**ENVIRONMENTAL ASSESSMENT REPORT**  
Section 75W of the *Environmental Planning & Assessment Act 1979*

**Collector Wind Farm (10\_0156 MOD 1)**  
**Modifications to infrastructure and blade diameter**

Figure 3: Proposed Modified Layout

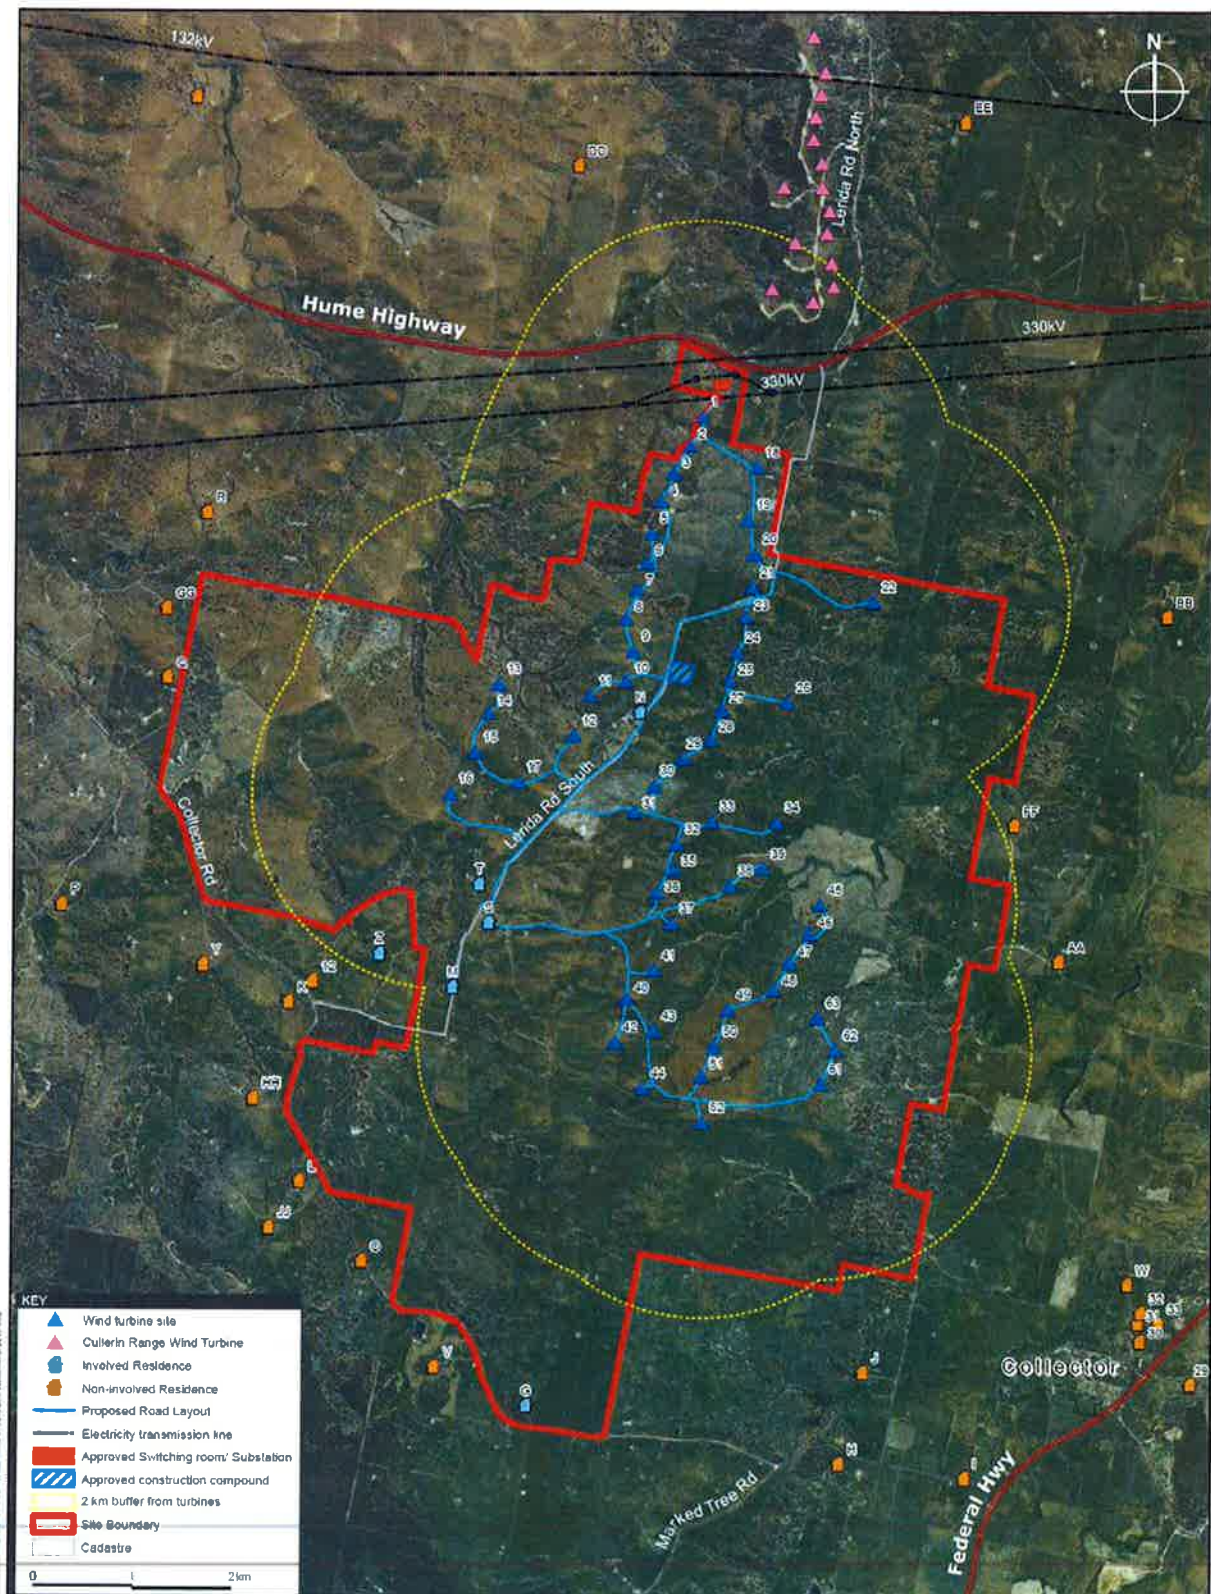
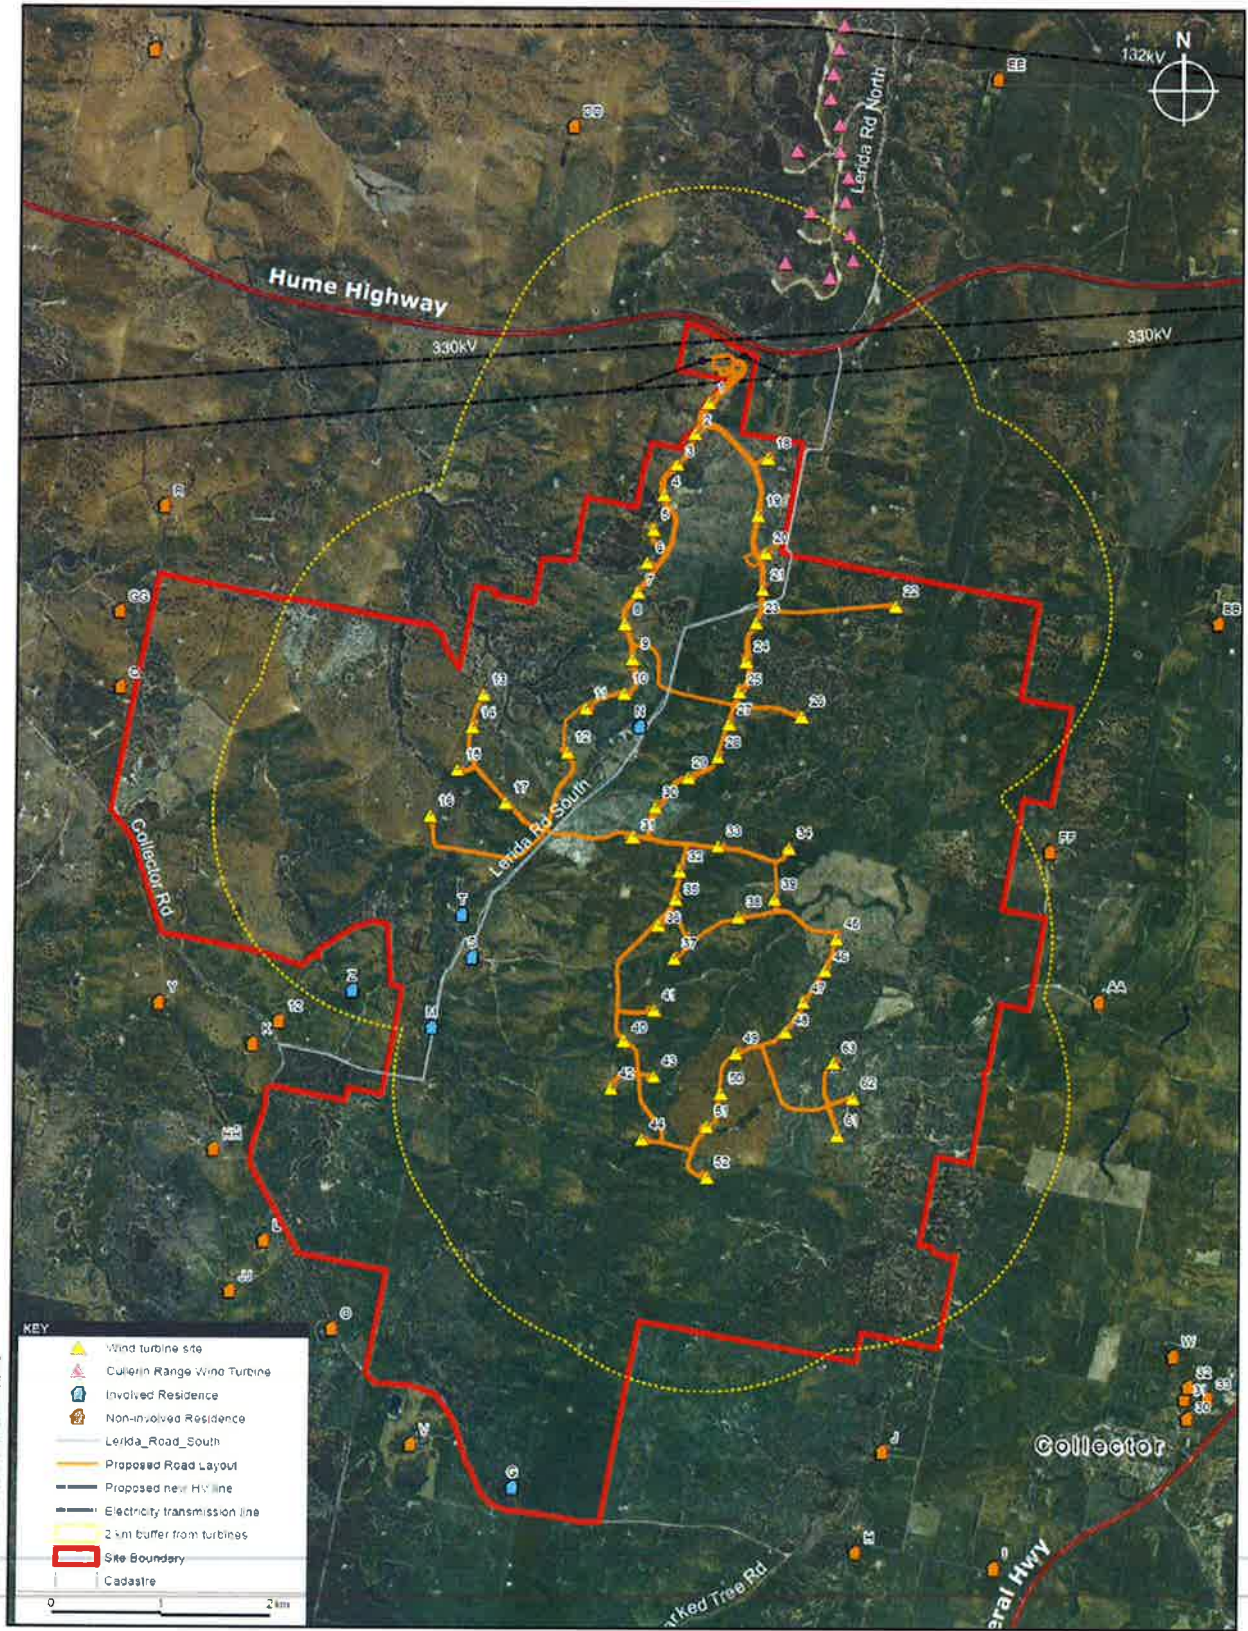
Ratch is proposing to make some changes to the internal road layout and site access in response to Council requests that the use of Lerida Road South be minimised. The changes also follow feedback from associated landholders and detailed design considerations that identified constraints with approved alignments of internal access tracks.

The modification would also reduce the number of intersections with Lerida Road South from 7 to 4.

In particular, the proposed modification would reduce the use of Lerida Road South by locating the main site access point at the earliest opportunity (2 km) south along Lerida Road South from its intersection with the Hume Highway, rather than 7 km for the approved project. It would also reduce the number of intersections with Lerida Road South from 7 to 4 (see **Figures 3 and 4**).

The Department consulted with Ratch about further reducing the number of intersections with Lerida Road South, including whether a single entrance/exit point could be used to access the entire site. However, there are a number of steep gullies across the site which would prevent access from the main entrance/exit point (e.g. between turbines 11 and 12), and site vehicles would have to travel large distances along internal access roads to navigate from one part of the site to the other side (e.g. from turbine 16 to turbine 52 would be around 15 km).

Consequently, the Department accepts that the proposed access arrangements strike an appropriate balance between minimising the use of Lerida Road South and facilitating reasonable access to the site.

The Department has recommended conditions requiring Ratch to implement the agreed road upgrades to the satisfaction of Council, and on balance considers that the proposed consolidation of the number of approved site intersections is a considerable improvement on the site access arrangements originally approved.

**Figure 4: Construction Compounds and Operational Buildings**

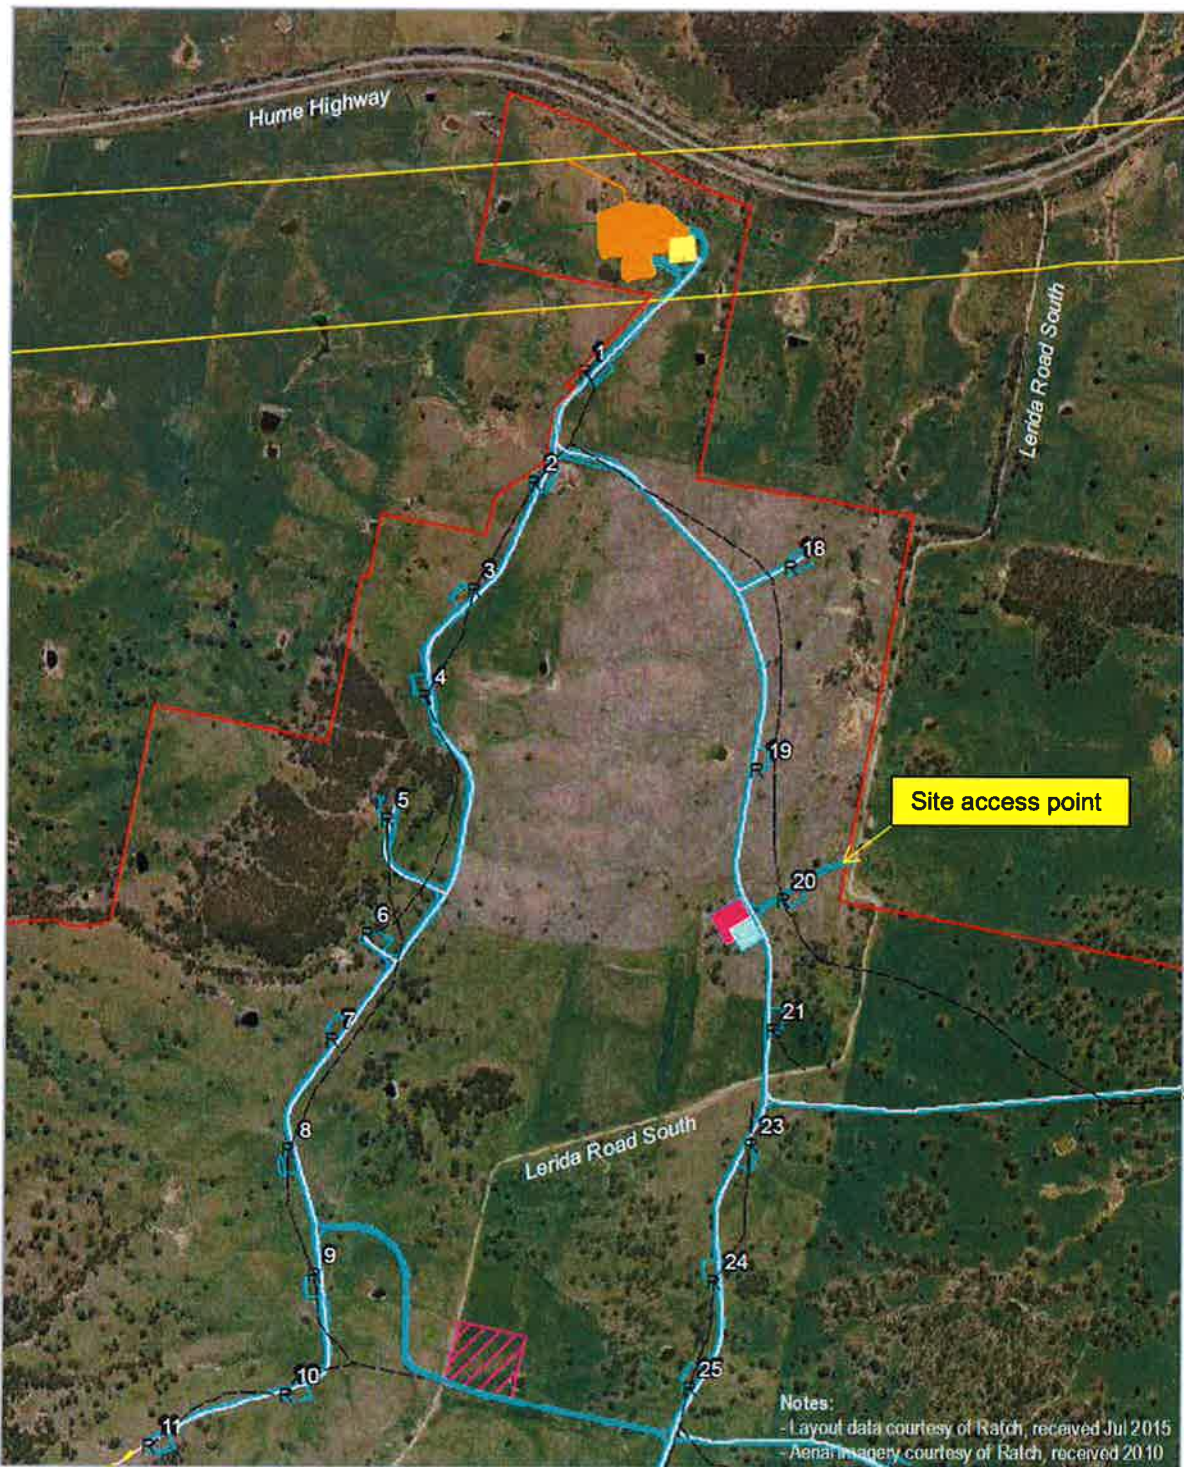
The proposed modification involves relocating the construction compound and operation/maintenance facility to a site adjacent to the new site access point. The proposed relocation reflects the modified internal road layout and would improve the efficiency of vehicle movements on the site during both construction and operations (see **Figure 4**).
